**1995****TOSHIBA** *Consumer Products***Date:** MAR 95**TECHNICAL BULLETIN****No.** VCR9501**Product:** VCR**Models:** M-650, 650C, 660, 660C, 750, 750C, 750J, 760, 760C, 760J, 770**Subject:** Power supply switching interference.**Ref. #:** 10A-9402**Symptom:** TV picks up power supply switching interference from VCR.**Required part(s):**

## POWER SUPPLY CIRCUIT DIAGRAM

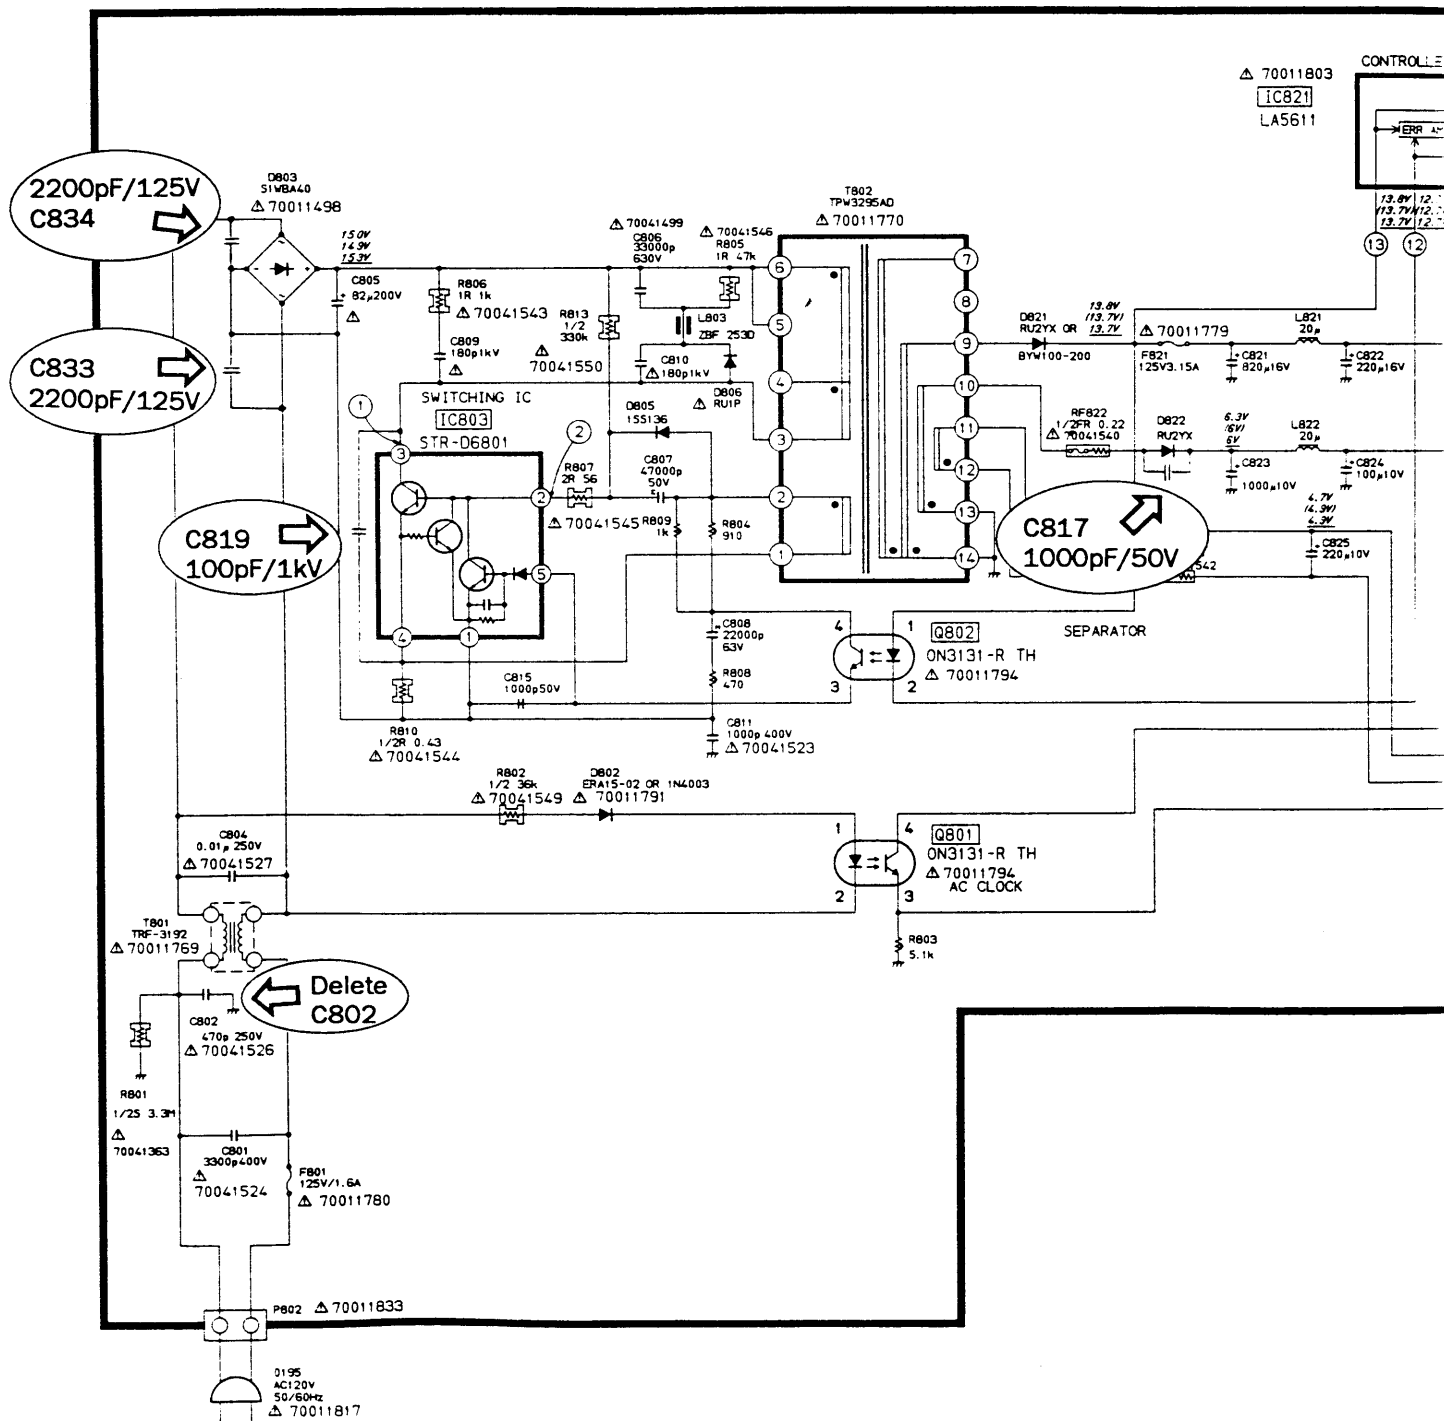
**Corrective Action:** 1) Remove capacitor C802.

2) Add 4 Capacitors, from 70903925 capacitor kit above, to the foil side of Main PC board, as shown in the illustrations on the attached sheet.

C802 Delete

C834 2200pF/125V

C819 100pF/1kV

C817 1000pF/50V

C833 2200pF/125V
